Revision 04: Height of bottom section of frame changed from 100mm to 94mm to accommodate lead flashing, width of top section of timber frame to sides of rooflight reduced from 72mm to 65mm. Top flashing/ back gutter detail divided into two sections to allow flashing to be installed before rafters/line sections and glazing are fitted. **Notes shown in blue text to highlight revisions**

PROJECT STATUS	RIBA Stage 5
CLIENT	Manchester City Council
PROJECT	Our Town Hall
DRAWING TITLE	Rooflight details
SIZE & SCALE	A1: 1 : 5
DRAWING STATUS	S4 Construction

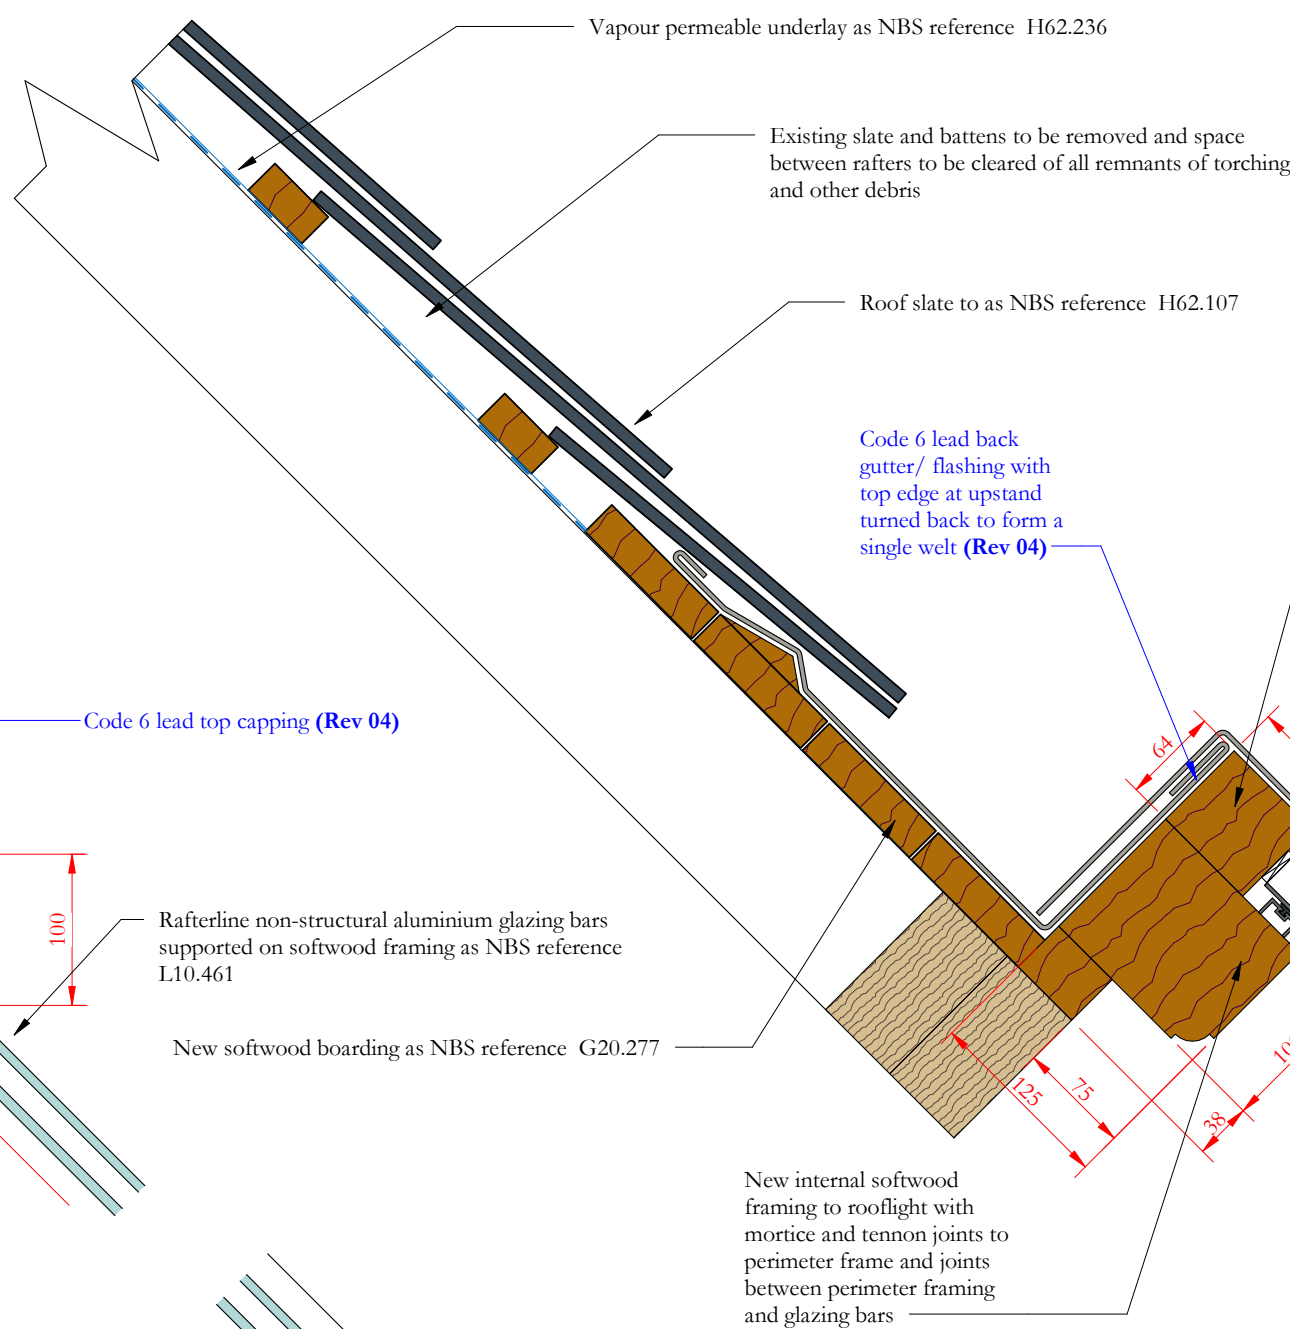
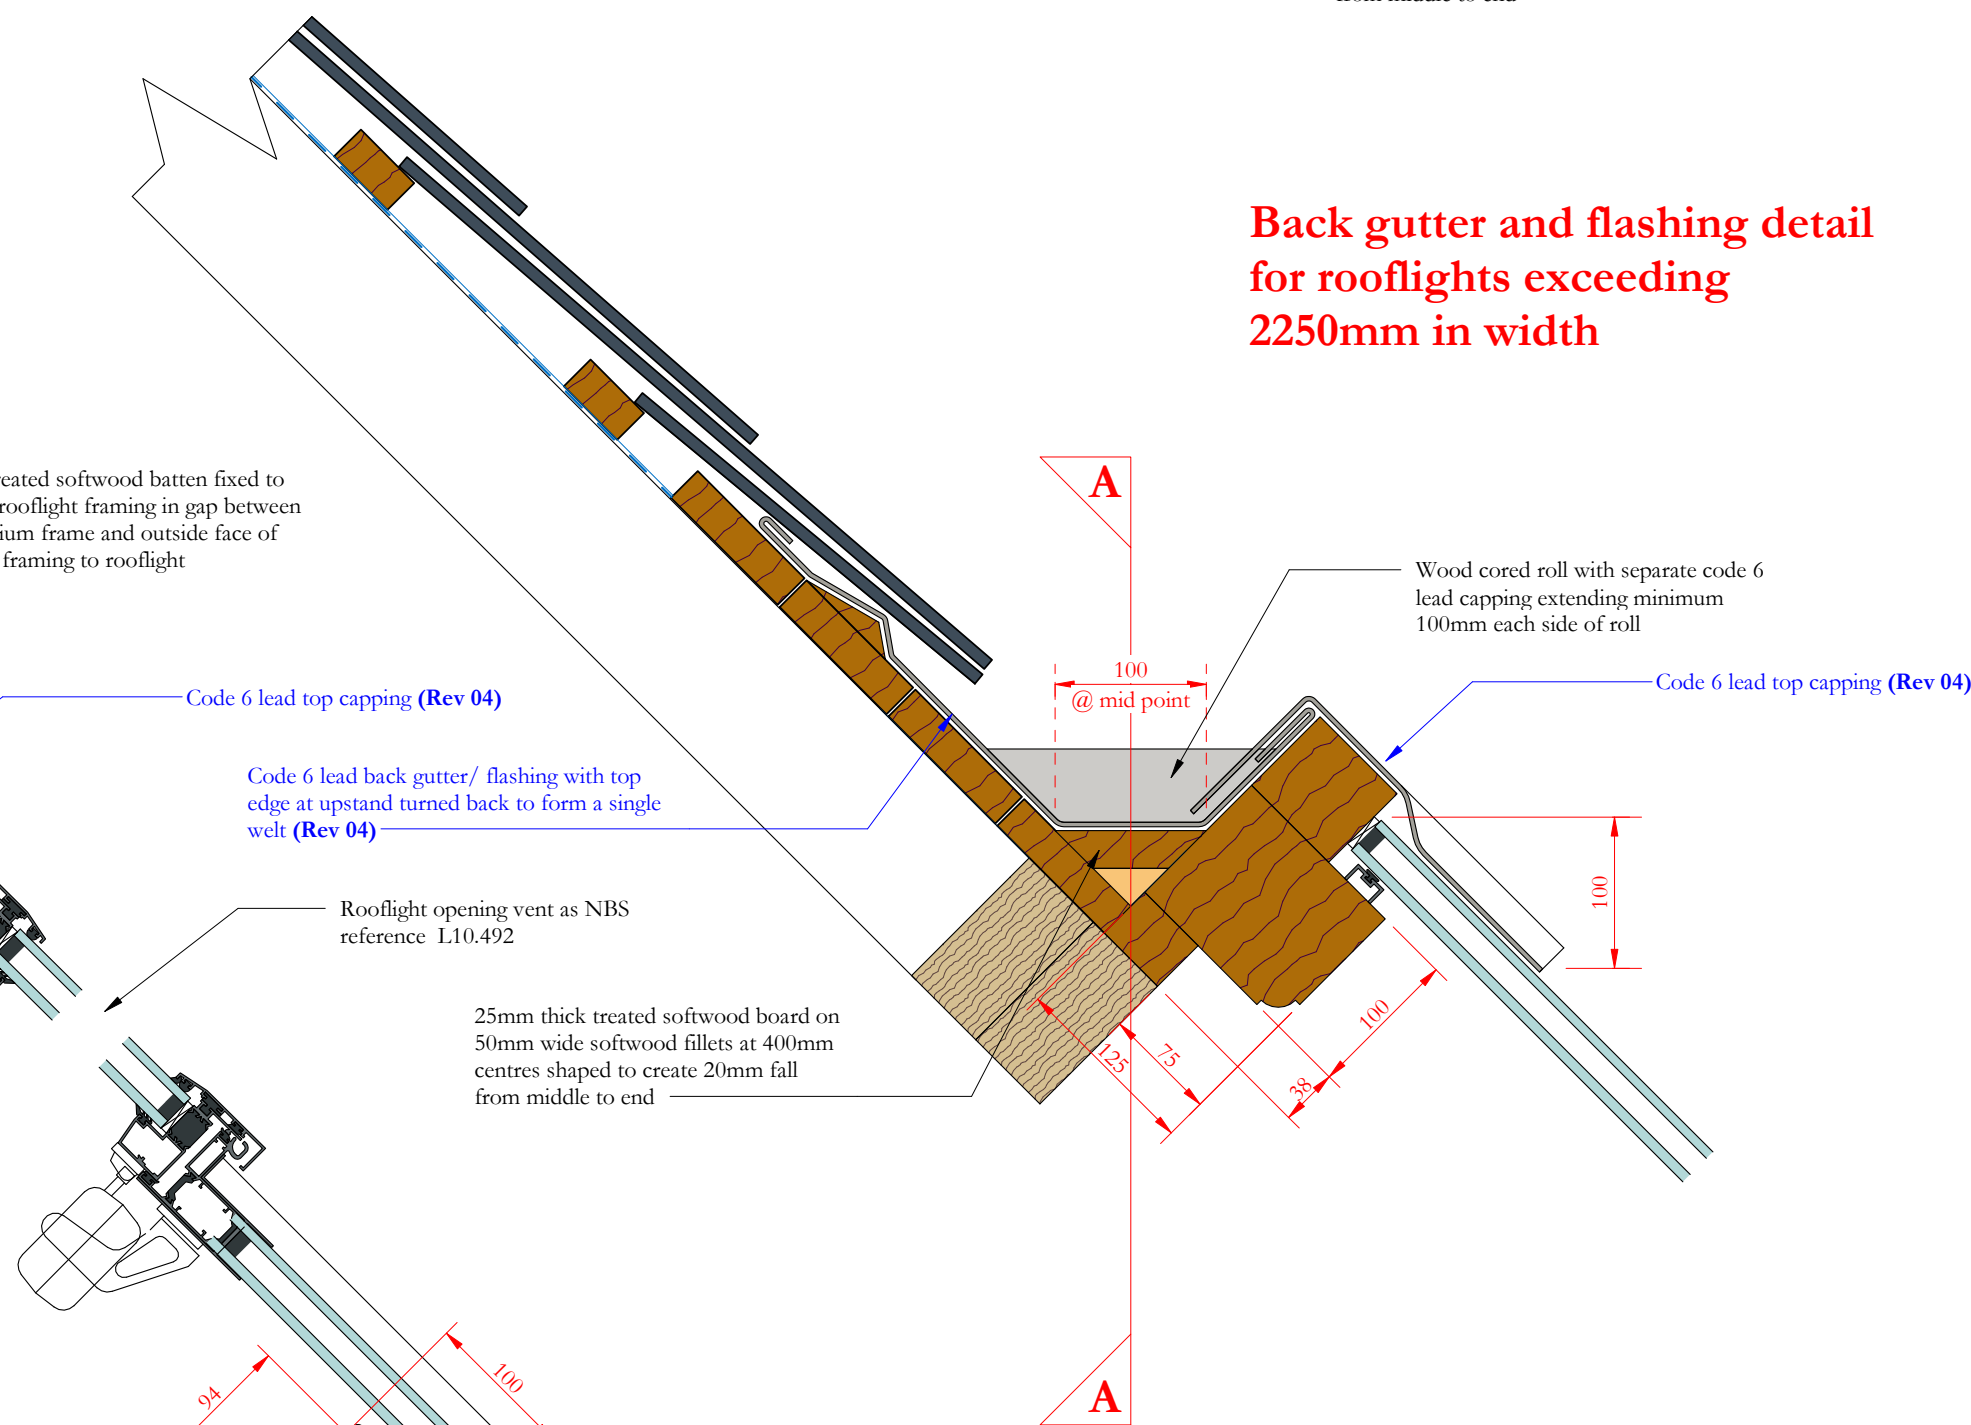
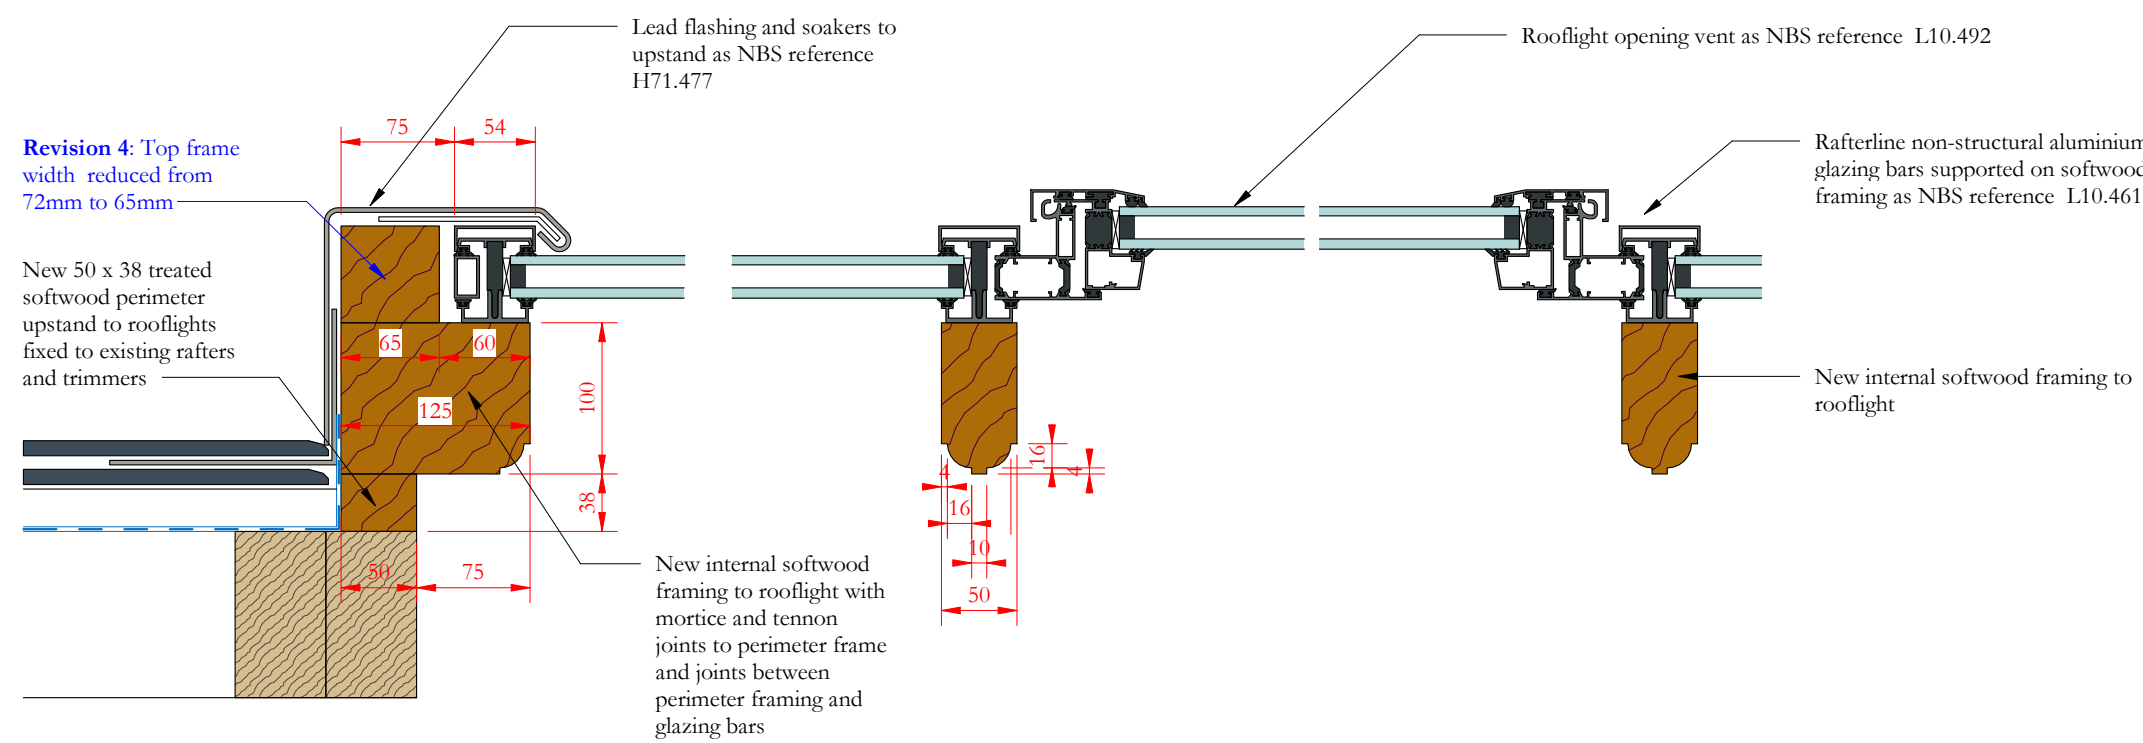
Revision 4 refers to rooflights in slopes SR09 (5 No.) SR11 (2 No.) WR16 (3 No.) WR18 (1 No.) WR07 (5 No.) WCR07 (2 No.) NR06 (5 No) and NR10 (1 No)

Revision 03: Back gutter detail added for rooflights exceeding 2250mm in width

Revision 02: Profile of glazing bars and width of perimeter frame amended to match original example. Notes amended.
